Texas Commission on Environmental Quality

Subject: Backup Documents Filed for Consideration of Hearing Requests at Agenda.

Applicant: US Ecology Texas, Inc.

Class 3 Permit Modification

Attachment B - Facility Map and Drawings

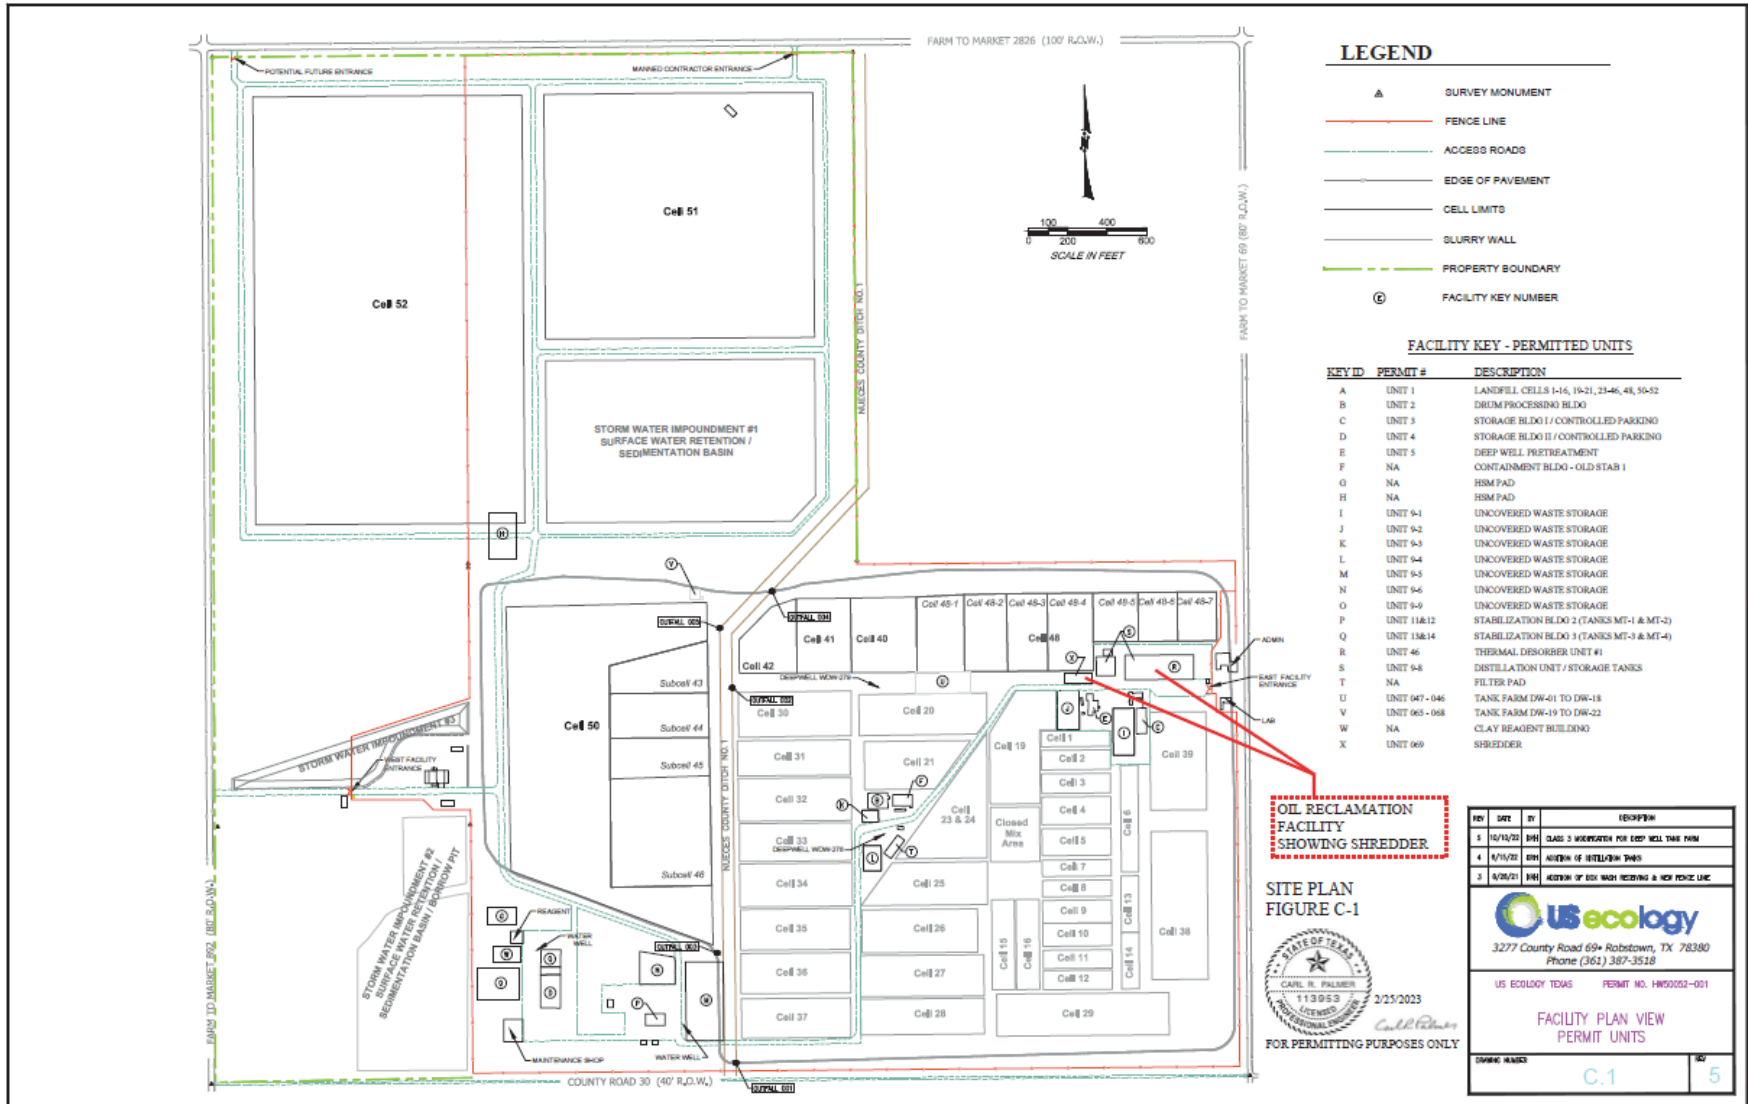
Replace Page 1 of 23 of the Attachment B with the revised Attachment B Page 1 of 23 (Attached)
